GOVERNMENT OF THE DISTRICT OF COLUMBIA
OFFICE OF PLANNING

MEMORANDUM

SUBJECT: Setdown Report, Zoning Commission Case No.03-12G and 03-13G
- Capper/Carrollsborg Venture LLC Hope VI Revitalization Project
- Request for Approval of 2nd Stage PUD for Squares 882 and 769

DATE: August 29, 2008

Figure 2: Square 882 Proposals

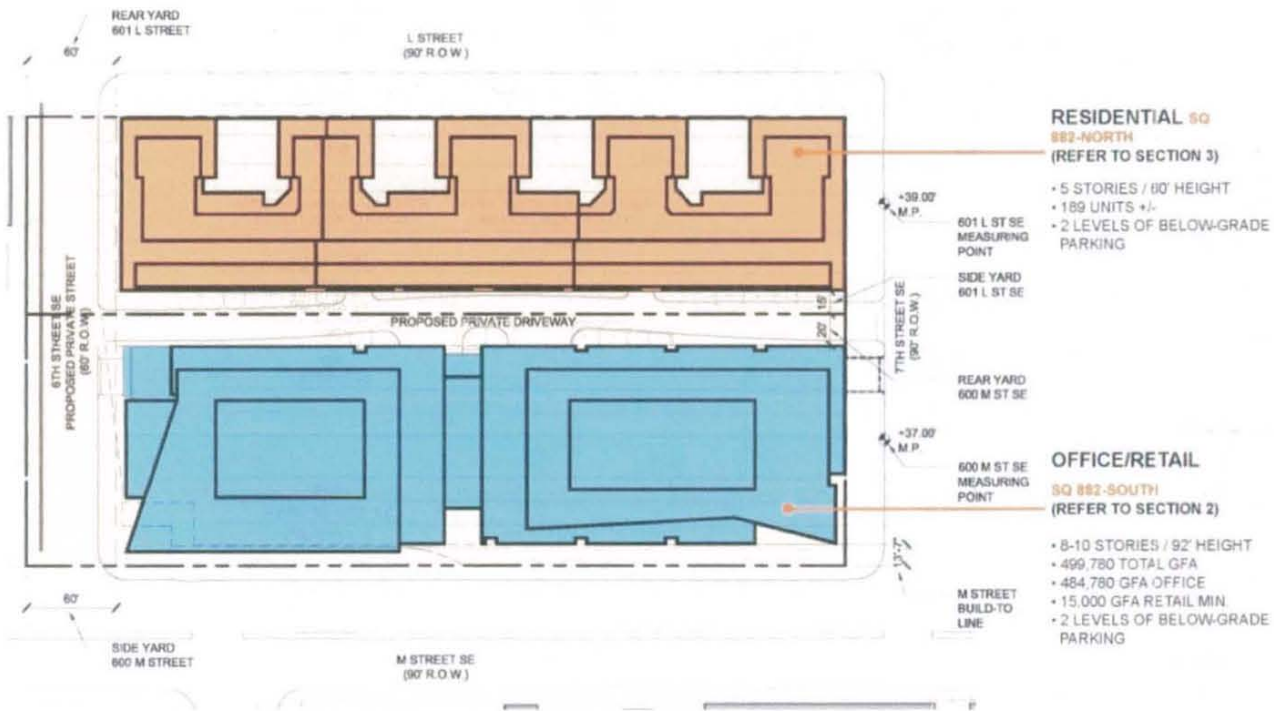
OP Comments: The applicant has asked for flexibility to construct one wing before the other. The more likely progression would have the west wing being constructed and occupied first, as a stand-alone wing. The complete office building would determine and measure its zoning height from 7th Street, on which the eastern wing would have frontage. Measured from 7th Street, the proposed building would measure 92' and would require 2 feet of relief from Order 03-12/03-13. Absent an eastern wing having frontage on 7th Street, the western wing by itself would draw and measure its permitted height from M Street. There is an approximately 24 foot decrease in elevation between the eastern and western ends of the proposed building. At the mid-point of its face on M Street, the western wing, standing temporarily alone without the eastern wing, would measure approximately 107 feet. This would be 17' higher than is permitted by the Preliminary PUD's Order. The western wing's zoning height would become 92' once the eastern wing was integrated with it.

While the request to phase construction is acceptable, and a 107-foot building fronting on the 90-foot M Street right of way, if the Commission sets down the phasing request the advertisement should note that the phasing would require temporary relief of approximately 17 feet from the Preliminary PUD order.

With respect to the requested parking garage access on 7th Street, DDOT has met with the applicant, and expressed the Department's concern about granting the curb cut for the driveway. Accordingly, the applicant has asked for flexibility from the Preliminary PUD Order, to permit there to be no curb cut on 7th Street, should it prove unnecessary. Therefore, OP recommends the Commission set down this request and continue working with DDOT on the curb-cut issue.

With respect to the additional 2-foot height request, OP recommends that it be set down and that the applicant explain more clearly the relationship between the required height for the retail space and the overall height of the building.

OP Comments: OP recommends this be set down. In the PUD cases original hearings, the Commission had expressed concern about the potential for the then-proposed 110' tall office building on the south side of the Square to overwhelm the townhouses proposed to the north. Accordingly, the Commission restricted the office building to 90'. Increasing the height of the residential building would further bring it into scale with the office building, and the additional square footage could also help to subsidize below-market rate housing.

Although the percentage of affordable housing would be the same 20% as in the approved building, the requested larger building would be providing more affordable square footage than would have the smaller approved residential building OP has asked the applicant to provide information on whether the increase in affordable housing in Square 882 would have any impact on the total amount of below-market housing, and on the amount of affordable housing previously proposed or approved for other parts of the PUD.

The applicant should clarify the access the below-market rate units will have to the development's amenities.

The applicant should also specify the limits of the range in the numbers of units it is requesting.

Table 4. Square 769 Residential Building Development Data

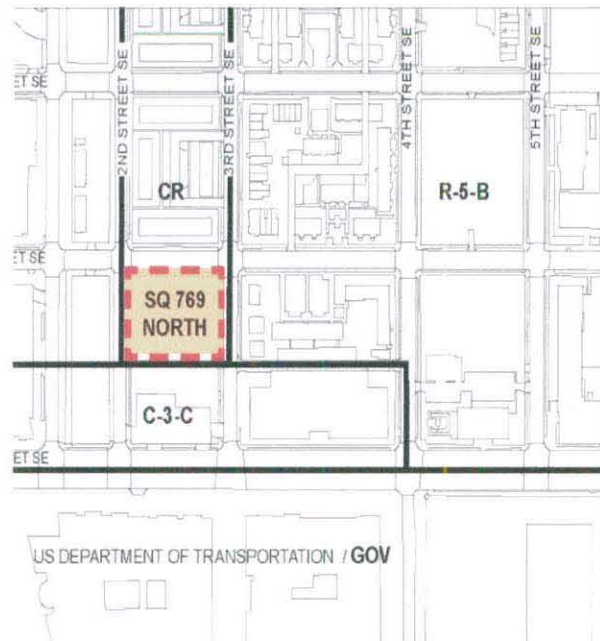
OP Comments: OP recommends this be set down. However, the applicant needs to clarify whether it is seeking relief from just the service delivery space, as is noted on page 11 of the application, or from the service delivery space and the loading platform, as is noted in the table on sheet 4.4 (which is reproduced above). The applicant should also provide additional information to justify the requested relief. This is not fully addressed in the Gorove/Slade Traffic Statement.

The applicant should specify the limits of the range of flexibility it is requesting for the number of residential units.

With the residential building being directly across from a major new planned city park, the requested relief from the public space requirement may be appropriate. However, to satisfy the spirit of that CR requirement, the applicant should consider an alternative, such as providing assistance to the Canal Blocks Park, the community center, etc.
